REQUEST FOR INFORMATION	DATE: March 14, 2017	NO.: RFI-482
--------------------------------	-----------------------------	---------------------

Project Name: 15051-Webster University Interdisciplinary Science Building	Project No.: 15051
---	--------------------

Subject: Alternate pre-rinse unit needed

PR1020 Pre-Rinse Unit

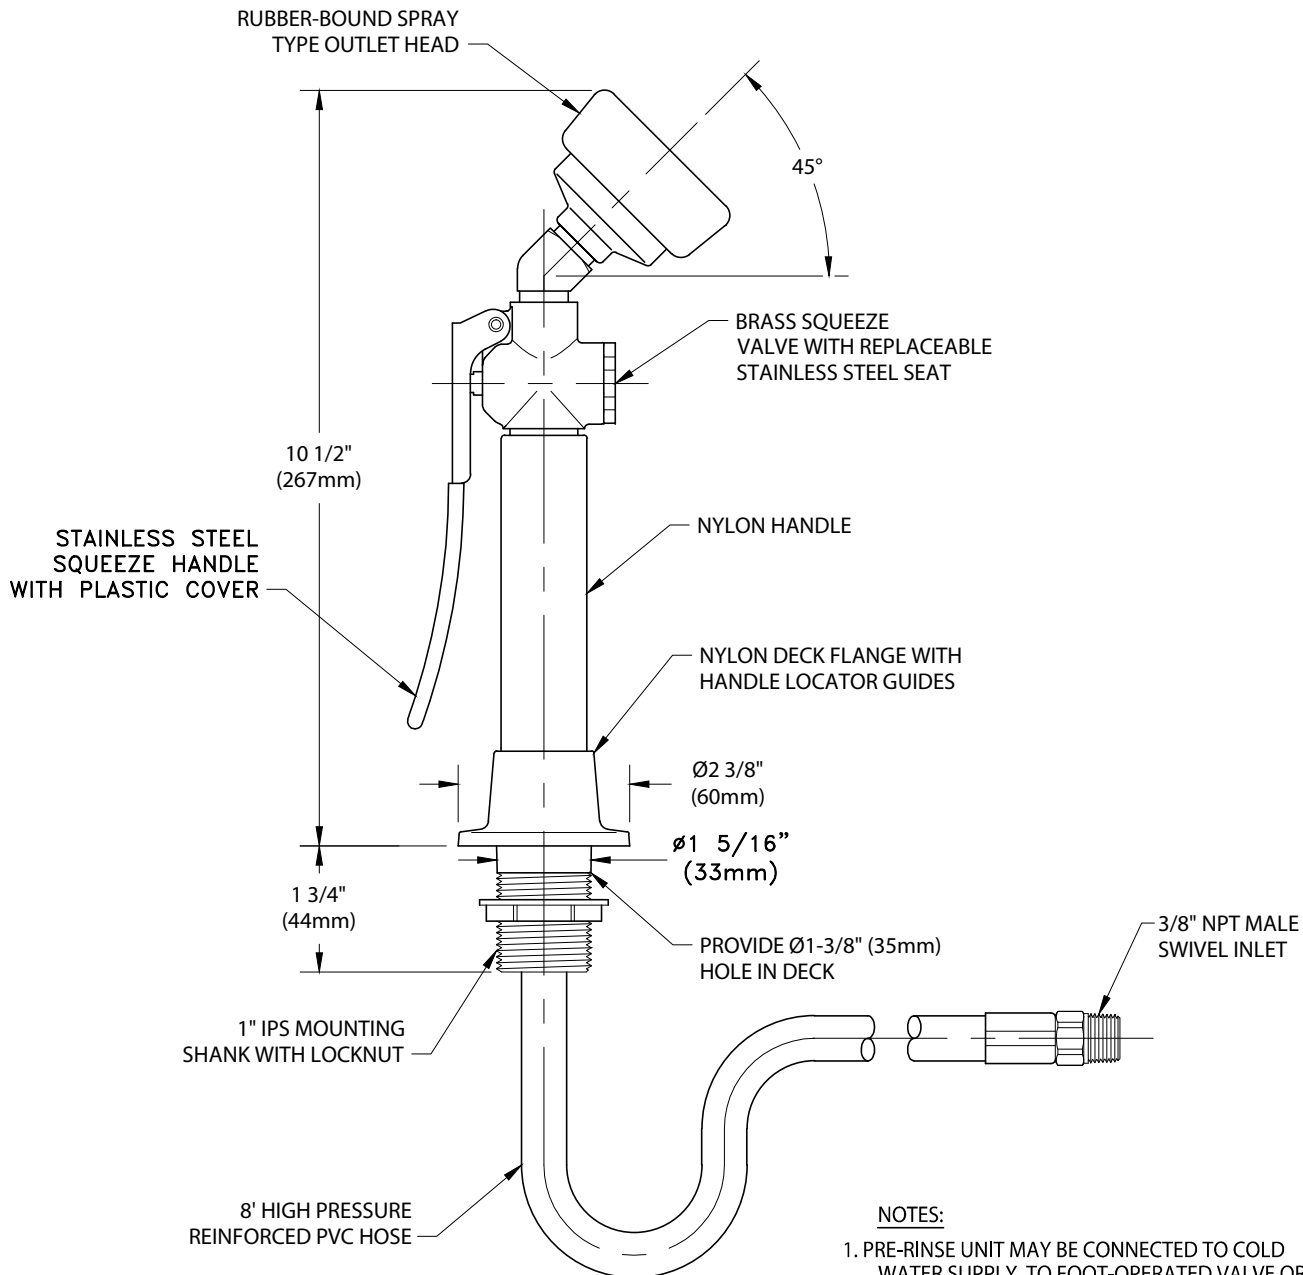
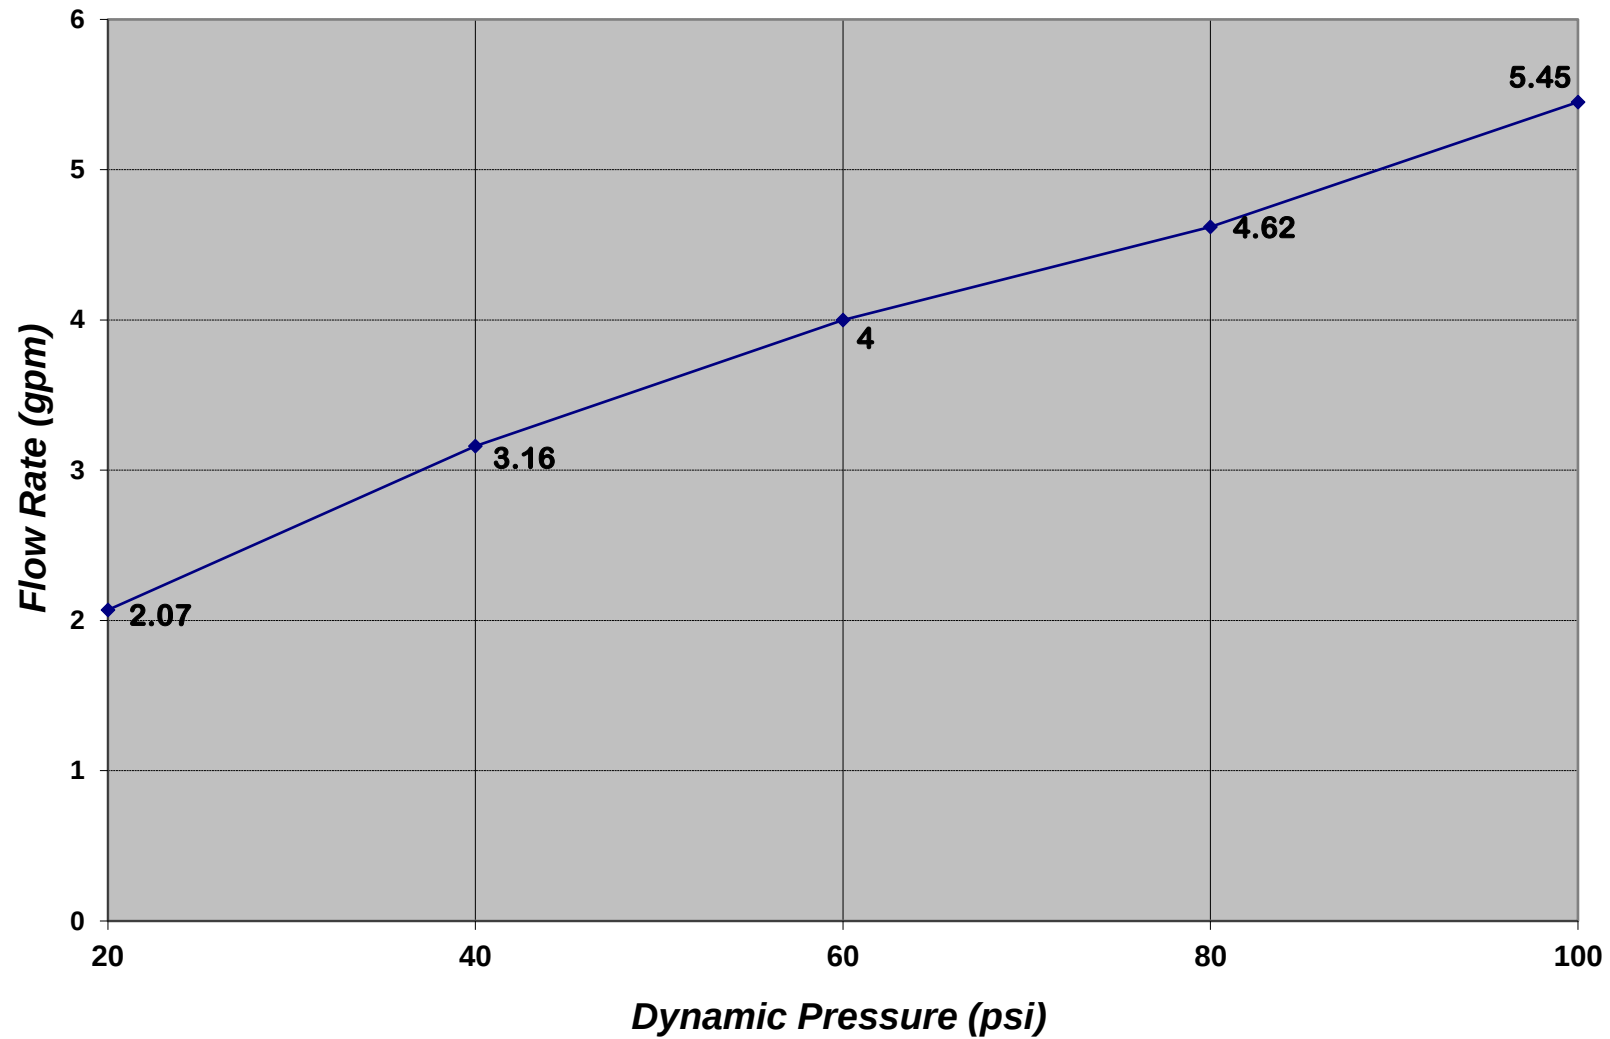
Cannon has asked for a shorter pre-rinse unit to be provided so that it may fit under the wall cabinets. The pre-rinse spec'd cannot be customized due to the spring that holds the drench hose in place.

Suggestion: Please spec an alternate manufacturer if desired to work with current casework design.

THE ATTACHED PRE-RINSE UNIT WHICH IS APPROVED BY THE OWNER IS ACCEPTABLE, PROVIDED WATER FLOW PRESSURE IS SIMILAR TO THE PREVIOUSLY SUBMITTED TALL PRE-RINSE UNIT.

PROVIDE PRE-RINSE UNIT WITH VACUUM BREAKER

VACUUM
BREAKER
REQUIRED
